PRODUCT / PROCESS CHANGE NOTIFICATION

1.1 Company		STMicroelectronics International N.V
1.2 PCN No.		ADG/21/12778
1.3 Title of PCN		SPC58NH92x (FC92): Activation of Additional Diffusion Plant and Package Upgrade
1.4 Product Category		see list
1.5 Issue date		2021-05-19

TITLE	SPC58NH92x (FC92): Activation of Additional Diffusion Plant and Package Upgrade												
IMPACTED PRODUCTS	<p>Below ST part number belonging to silicon line FC92:</p>

▲ TQFP 20x20

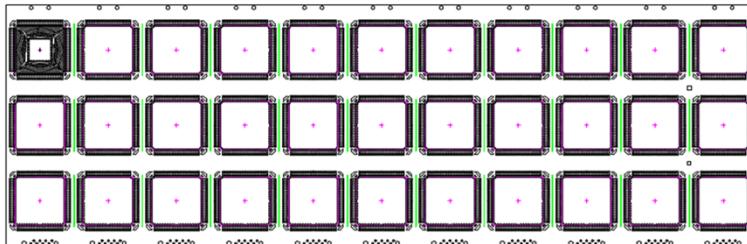
Package	Lead Frame	Lead frame finish	PKG Terminal Finish
20x20	Exposed Pad	Layout 3 x 11	Base Material Cu Pre-plated NEAP
24x24	Exposed Pad	Layout 3 x 9	Base Material Cu Pre-plated NEAP

New Lead Frame Layout | 100 x 300mm

▲ TQFP 20x20

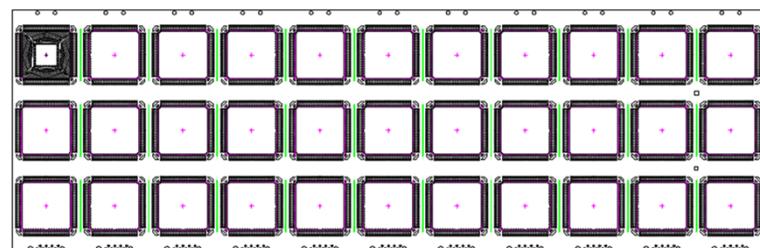
Package	Lead Frame	Lead frame finish	Terminal Finish
20x20	Exposed Pad	Layout 3 x 11	Base Material Cu Pre-plated NEAP
24x24	Exposed Pad	Layout 3 x 9	Base Material Cu Pre-plated NEAP

New Lead Frame Layout | 100 x 300mm

-- NEAP Finish -- Sn Finish

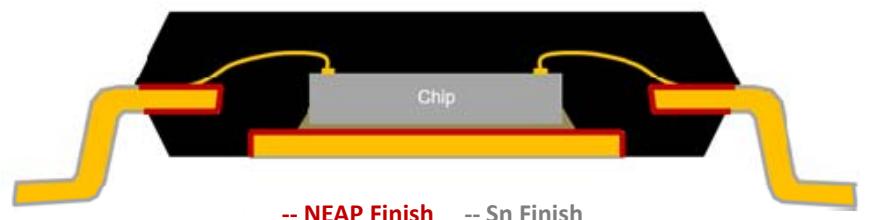
Leadframe Finish NEAP Non-Etched Adhesion Promoter

— NEAP Surface Finish for Package Reliability | Adhesion Enhancement

Button Shear Adhesion Test | EMC adhesion increases by more than 2 folds.
Package Reliability is the same as the current *μ*rough Pre-Plated Leadframe.
